**ADDENDUM  
NO. 02**

**March 14, 2022**

**Warren Central High School Phase 3 Renovation and Addition  
9500 E. 16<sup>th</sup> Street  
Indianapolis, IN 46229**

This Addendum consists of Pages ADD 2-1 through ADD 2- 5, and attached CSO Architects Addendum No. 2 , dated March 13, 2023, consisting of 11 Pages, Specification Section 02 01 00 – Maintenance of Existing Conditions, and Addendum 2 Drawings: C101, C102, C401, C501, C502, C503, LD001, L101, L106, L201, L206, L301, L306, S201PRT, S202PRT, S501, S601, AD201N, A201M, A201N, A202N, A211G, A211M, A211N, A401, A404, A423, A431, A432, A600, A601, A602, A603, A611, A612, A701, A702, A703, A800, A801F, A801J, A801M, A801N, A801P, A801R, A801T, A802F, A802N, A802P, A802R, A802T, A900A, A900B, A901K, A902U, A903, A904, A905, A906, MD201F, MD201H, MD201J, MD201K, MD201L, MD202HJ, MD202N, M201F, M201J, M201K, M201L, M201N, M202HJ, M202N, M211F, M211H, M211J, M211K, M211L, M211N, M212HJ, M301, M303.

3.21 SHEET A202N – SECOND FLOOR PLAN – UNIT N

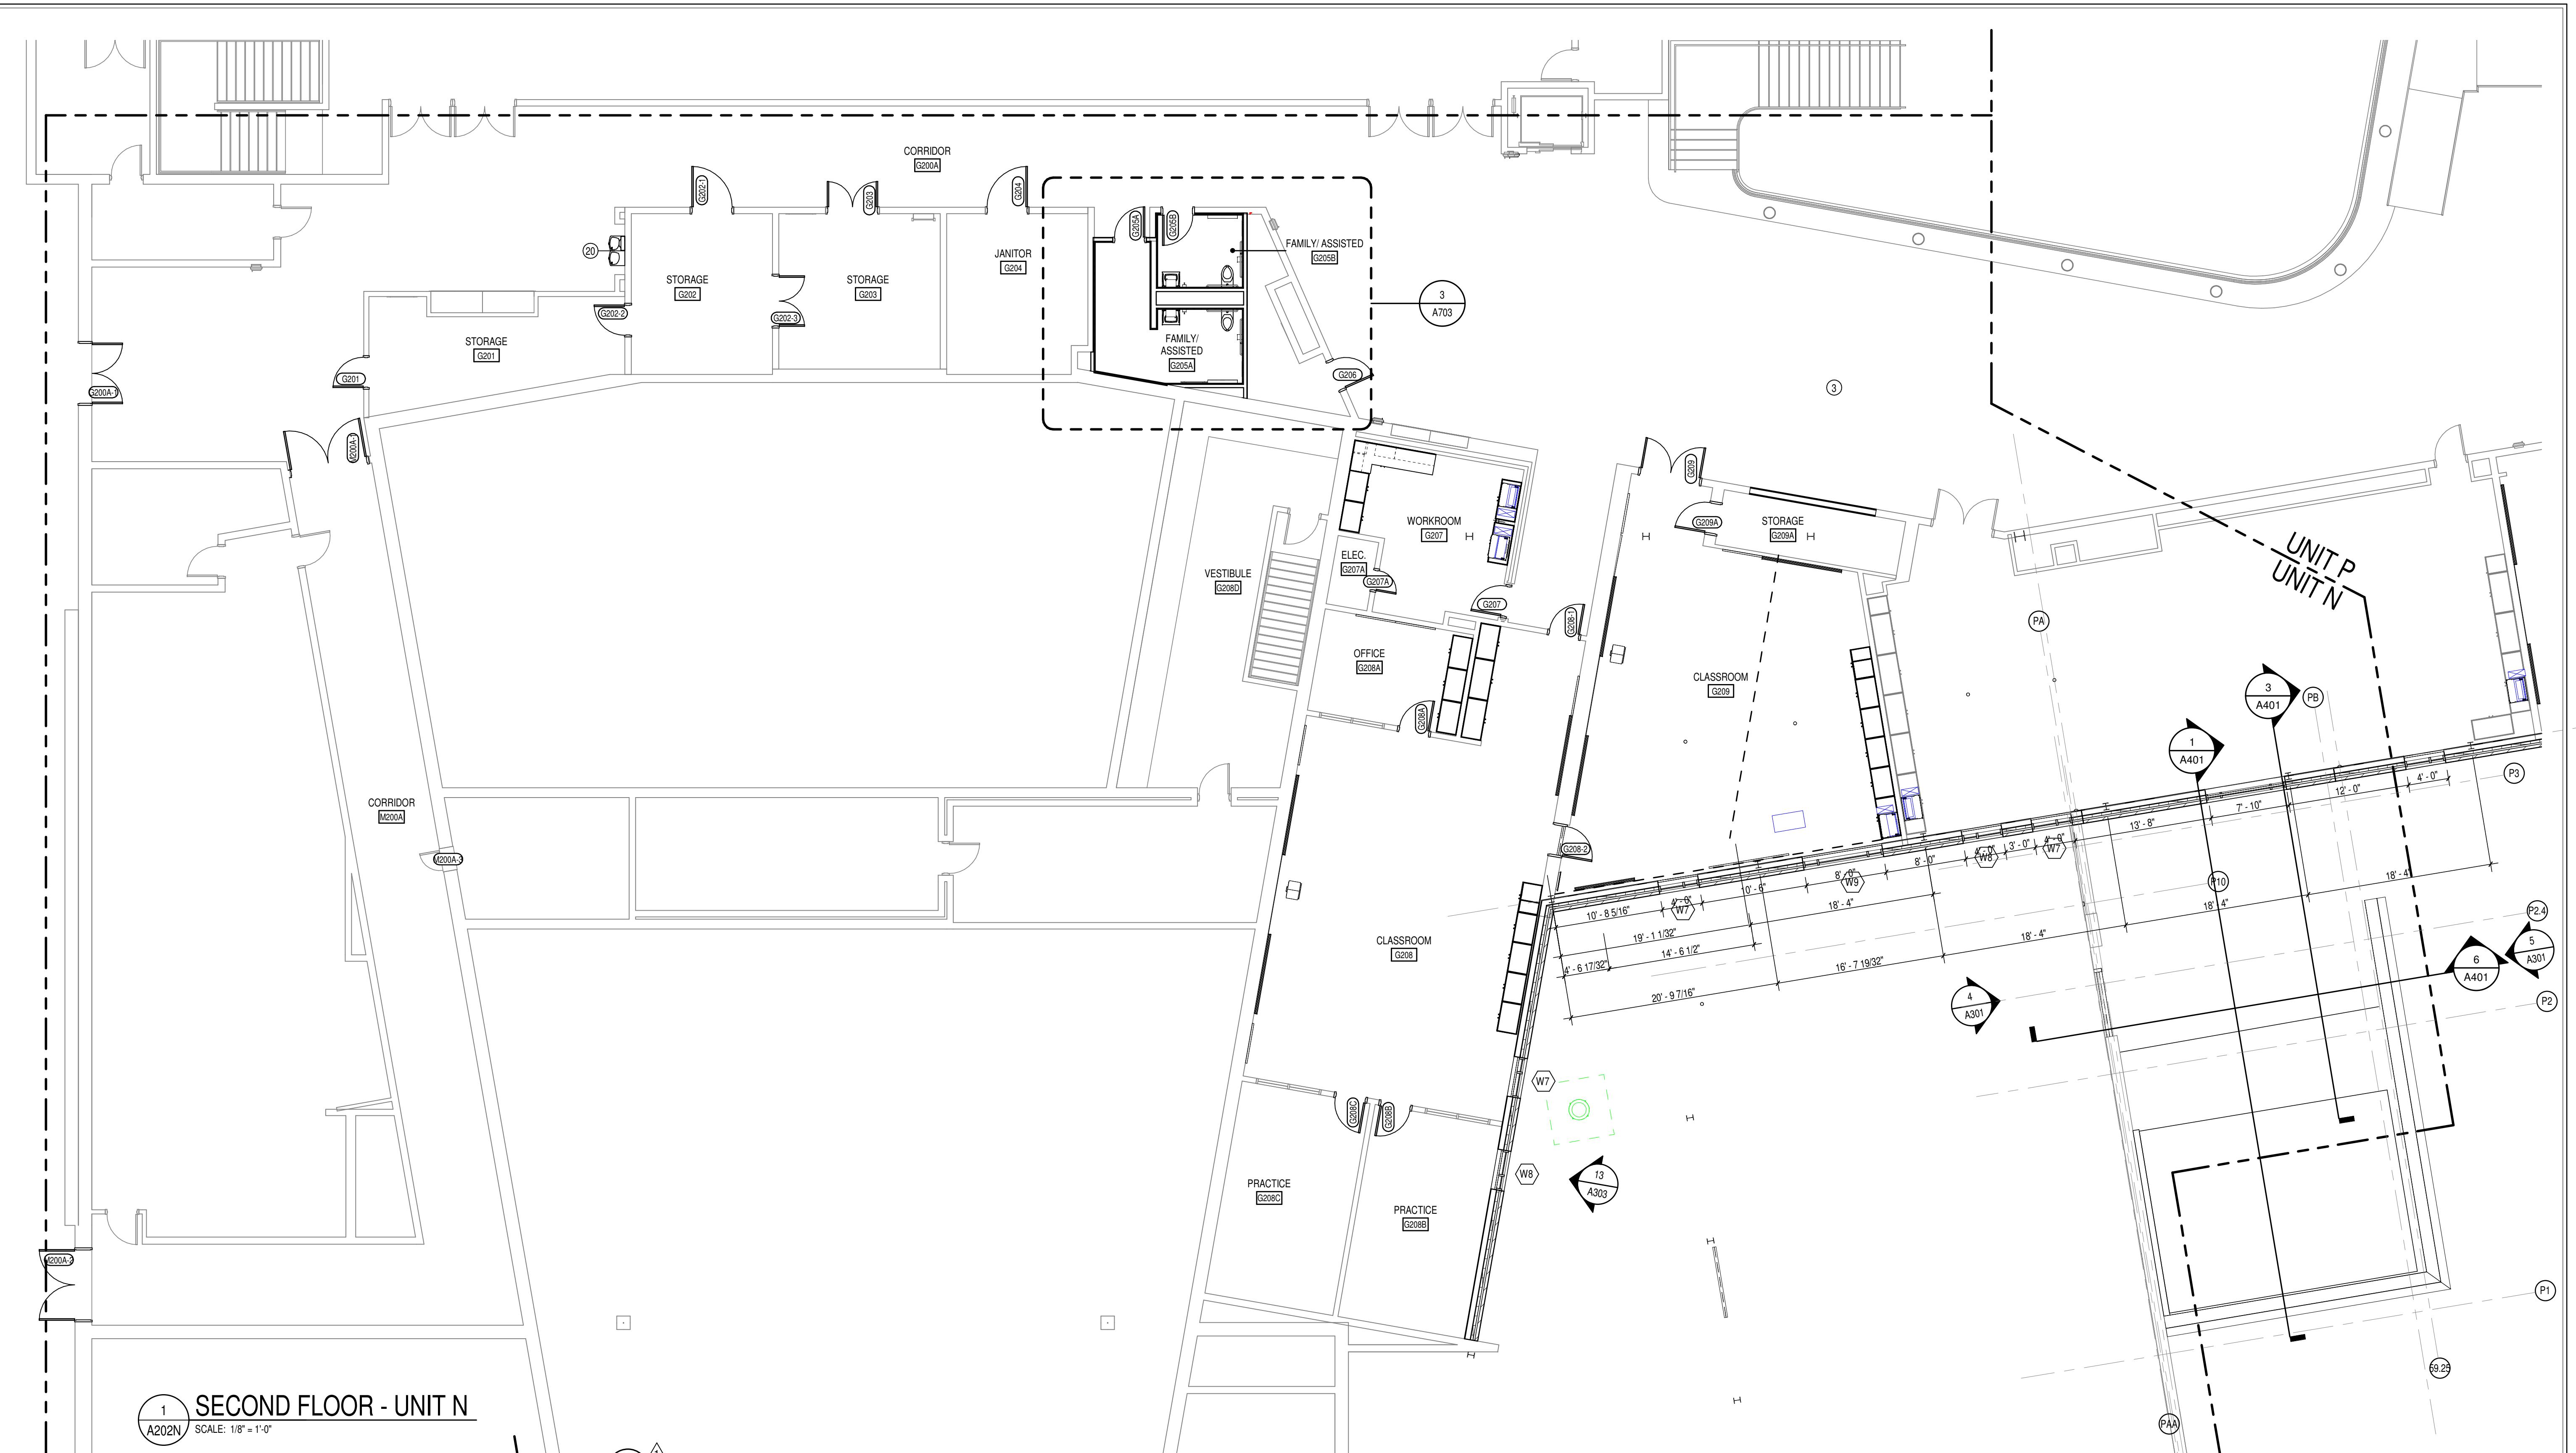
A. REVISE 3/A202N as indicated on attached, re-issued Sheet A202N

3.22 SHEET A211G – FIRST FLOOR REFLECTED CEILING PLAN – UNIT G

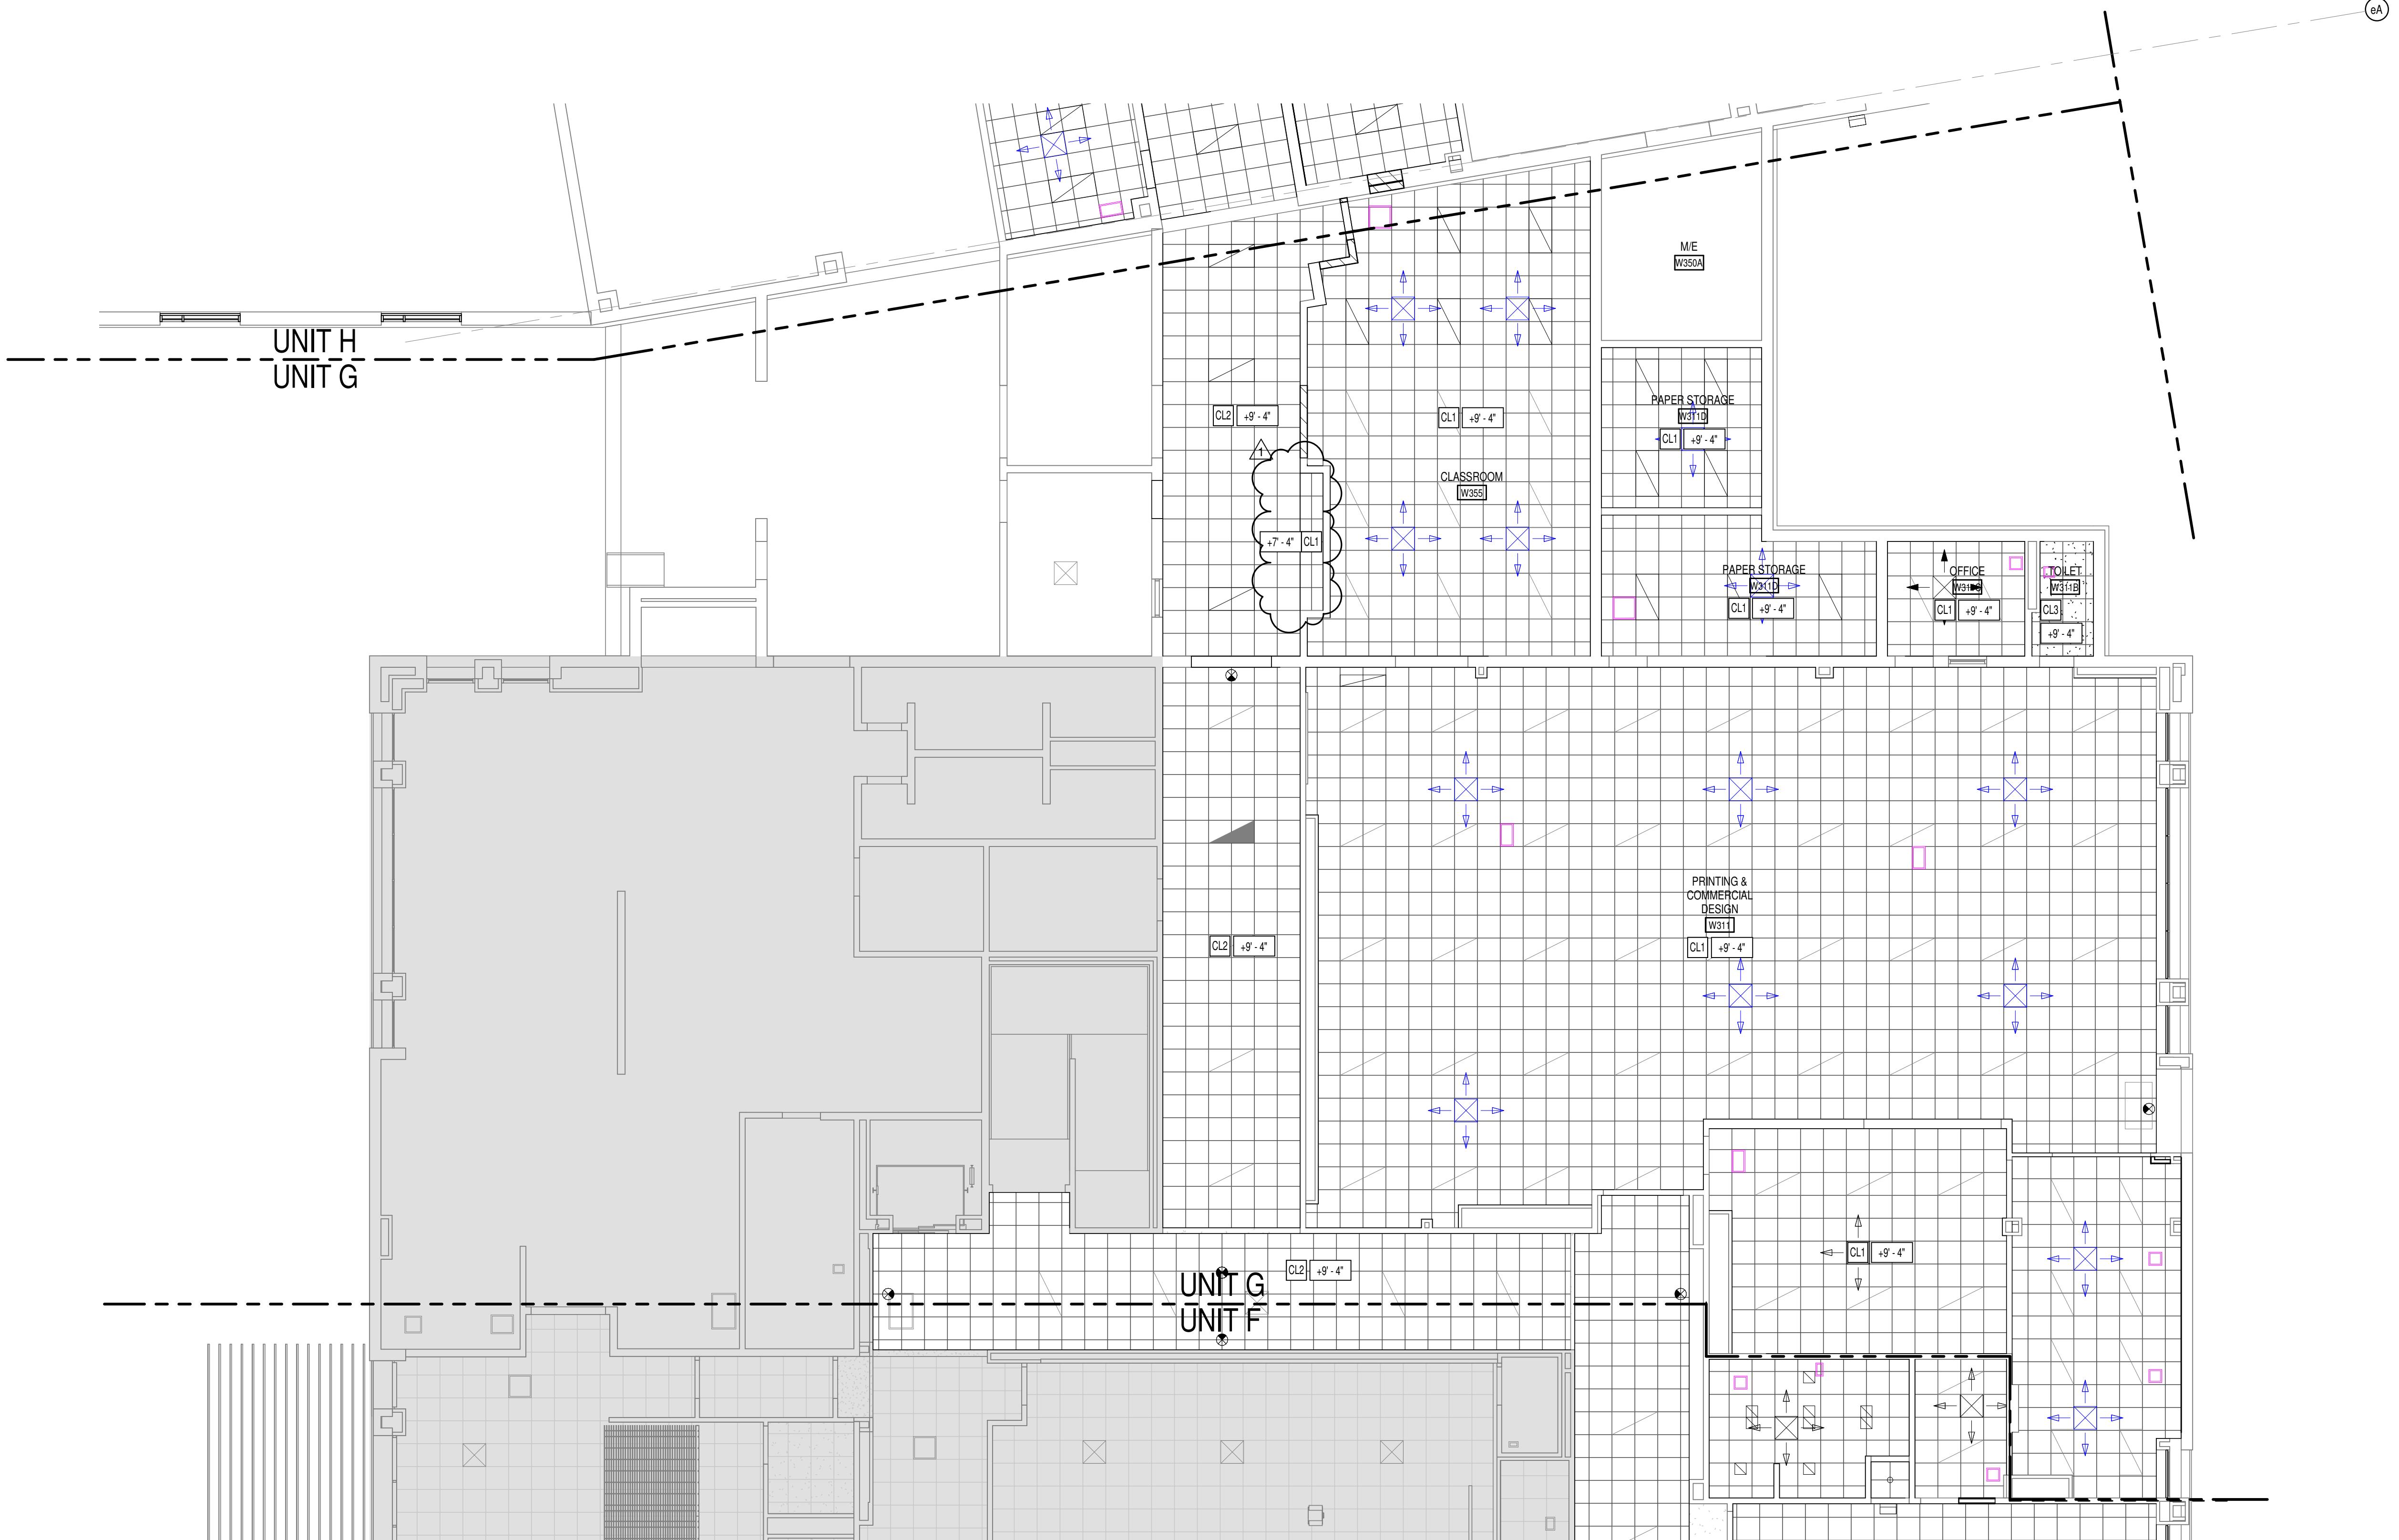
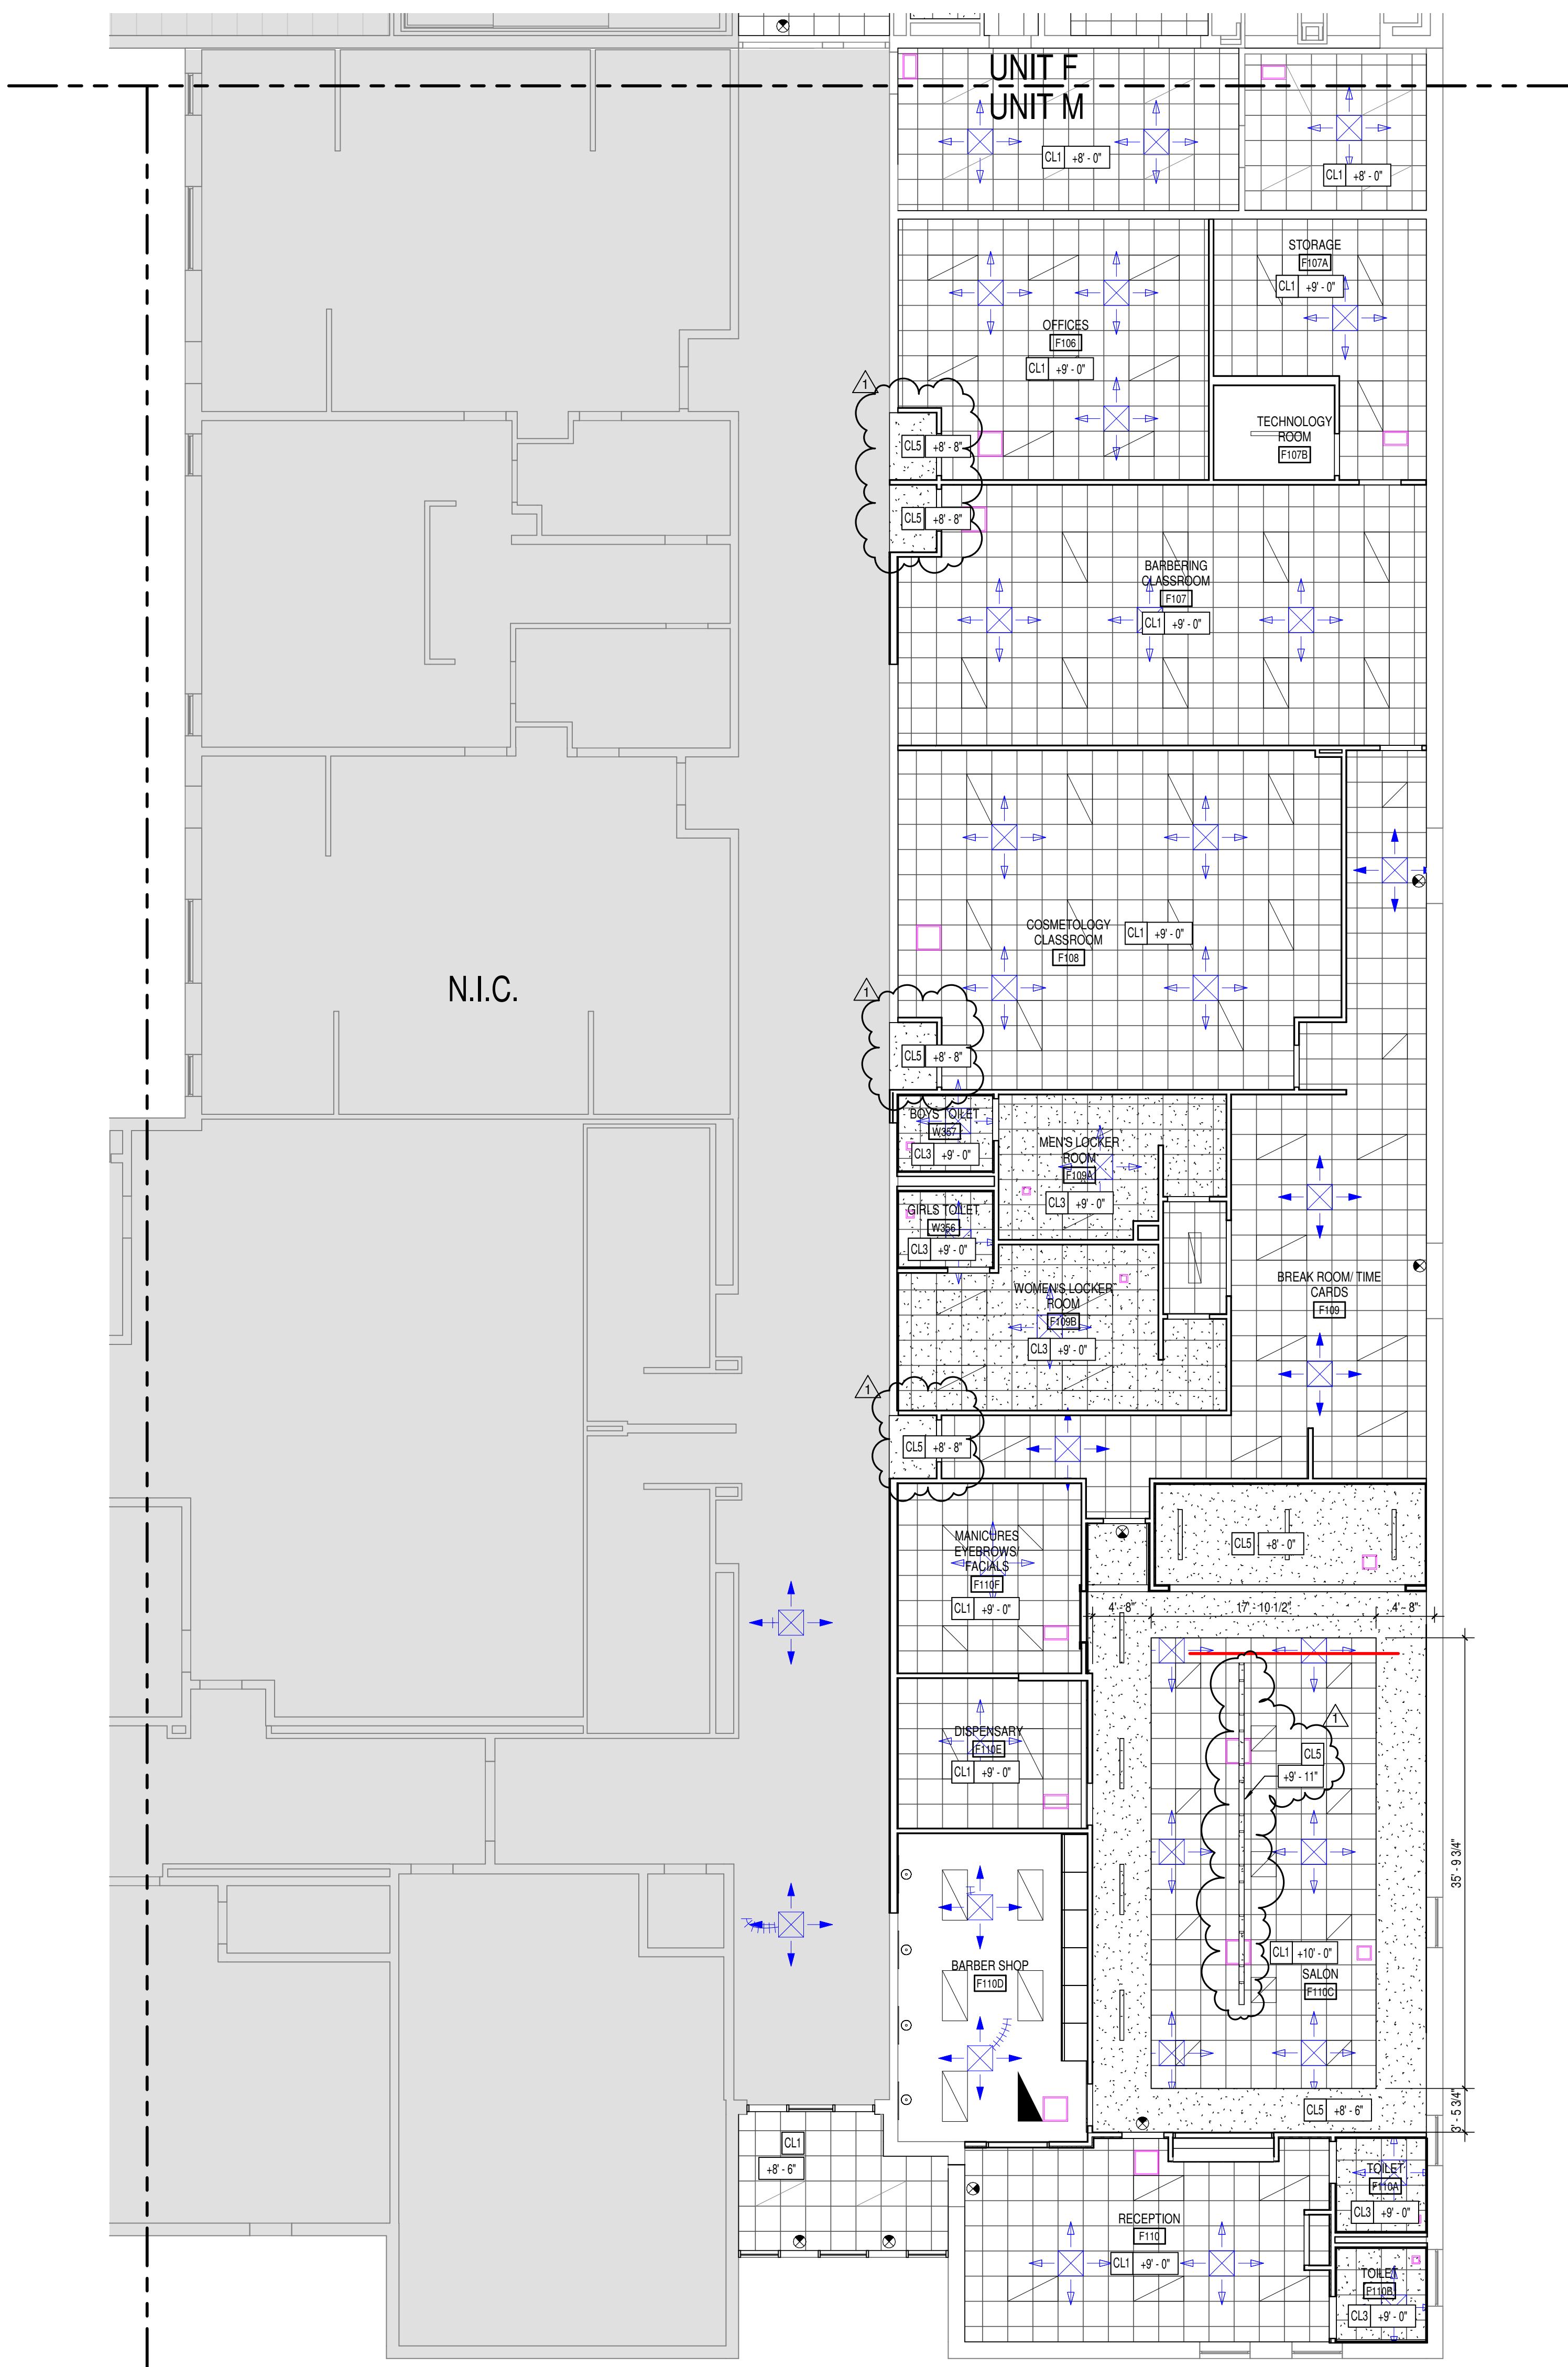
A. REVISE Ceiling at Corridor W000D as indicated on attached, re-issued Sheet A211G.
